ADDENDUM NO. 1

Issue Date: September 15, 2023

Project Name: Renovation of the Jones' Pier Conservation Area Bungalow

Bid Number: 2024009

PHASE I PAVING, GRADING AND DRAINAGE PLAN

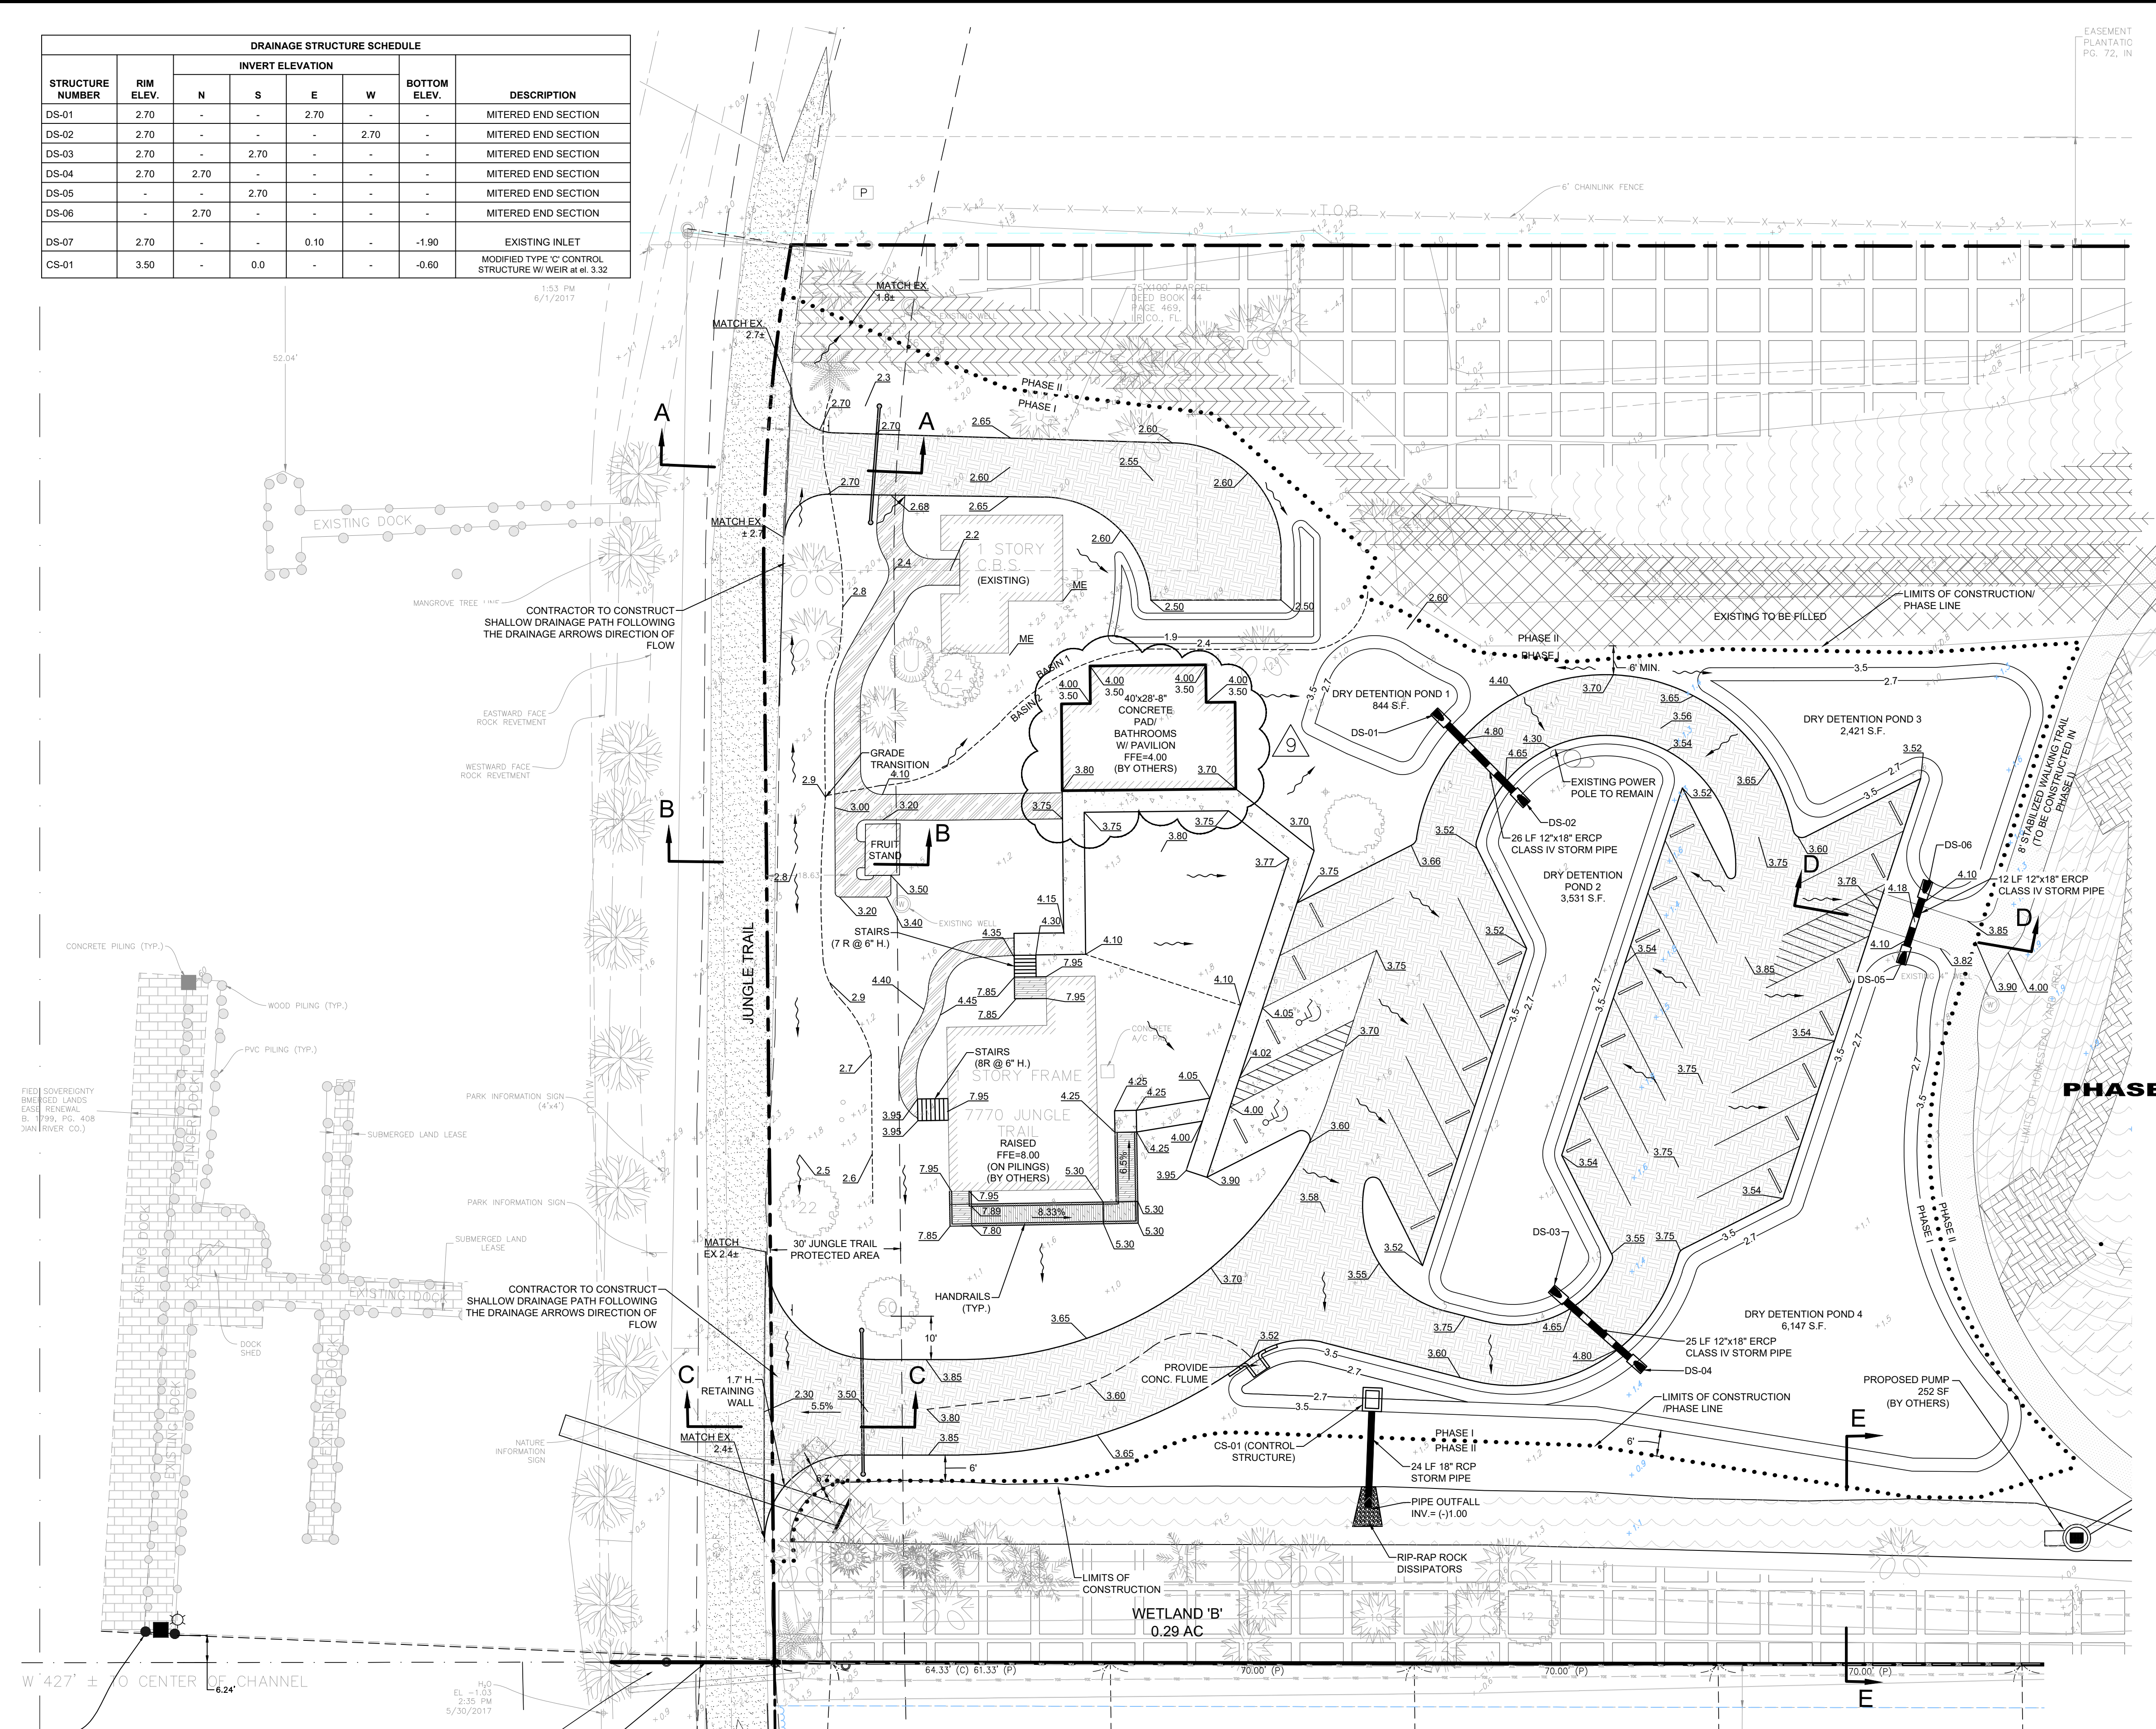
Grading Plan Sheet C-7 prepared by MBV Engineers dated 10/17/2018
Probable Cost of Construction Estimate
Civil Utility Plan, Sheet C-9 prepared by MBV Engineers dated 10/17/2018
Electrical Sheet E0.1 as prepared by Kamm Consulting dated 4/24/2020
Asbestos Survey

UTILITY PLAN ENLARGEMENT

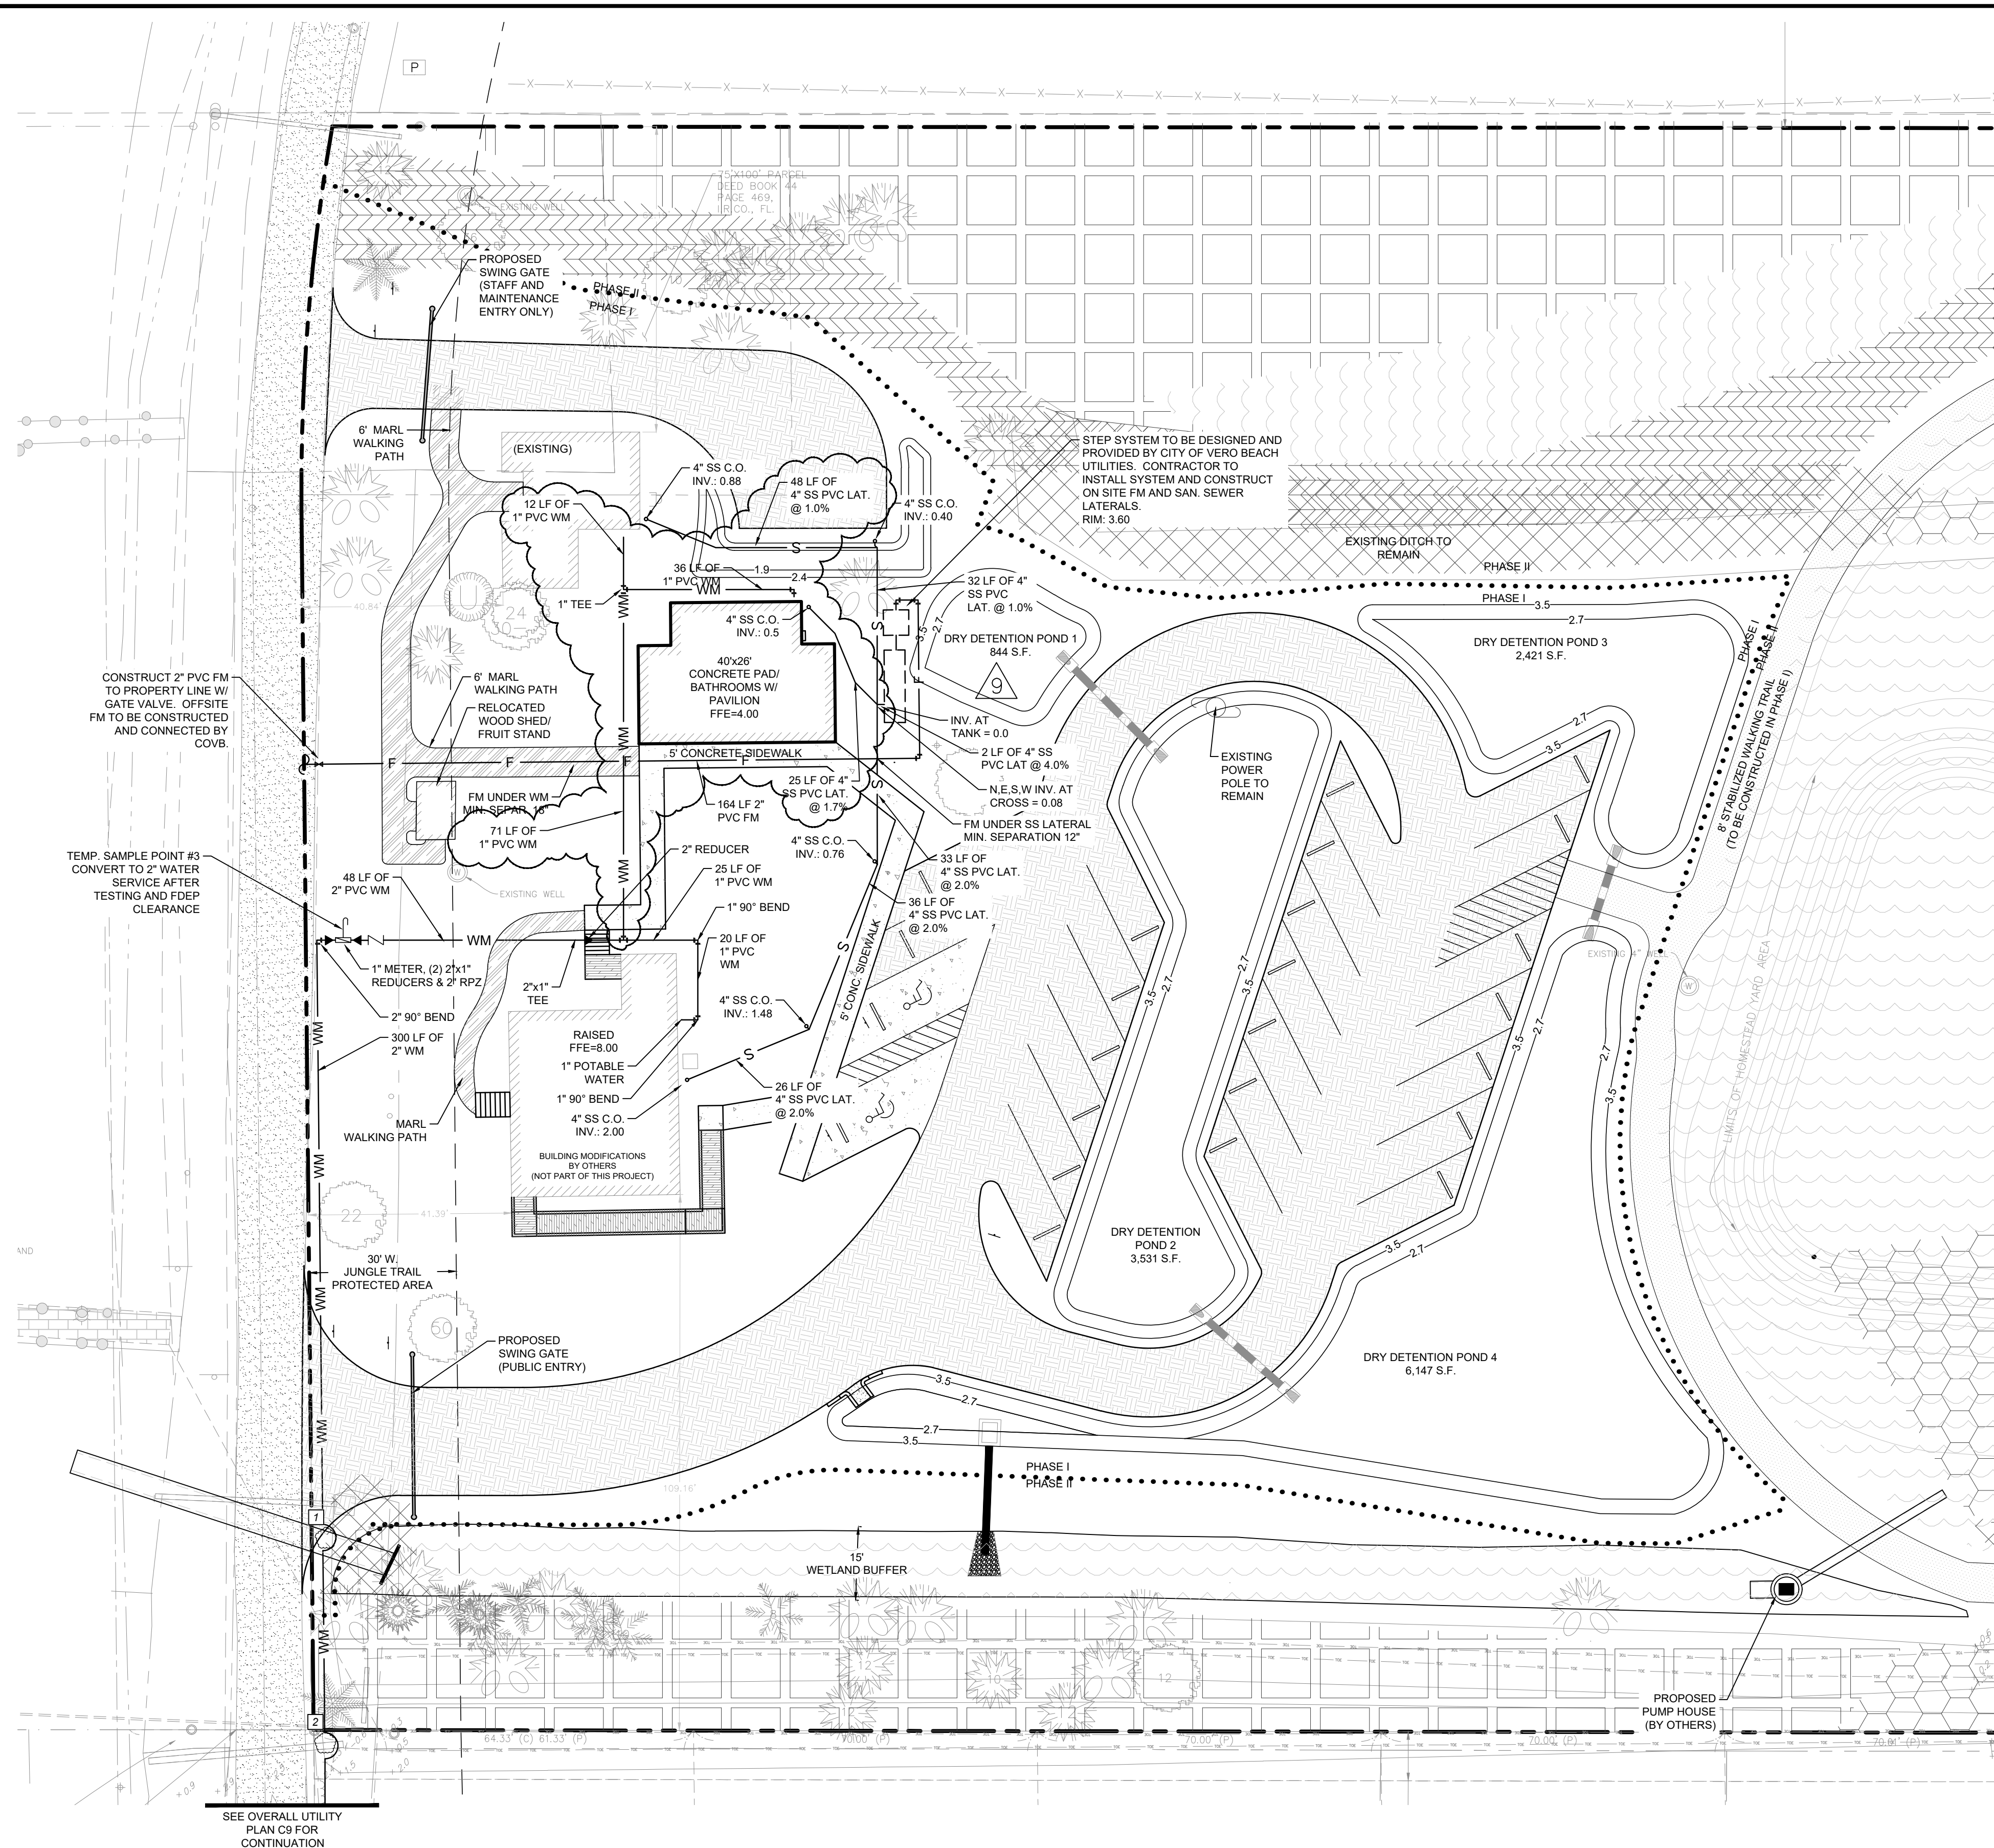
8. Are there any existing underground utilities within the project site and to service this building?
See attached previous project Civil Utility Plan, Sheet C-9 as prepared by MBV Engineers dated 10/17/2018 for reference of in place utilities.
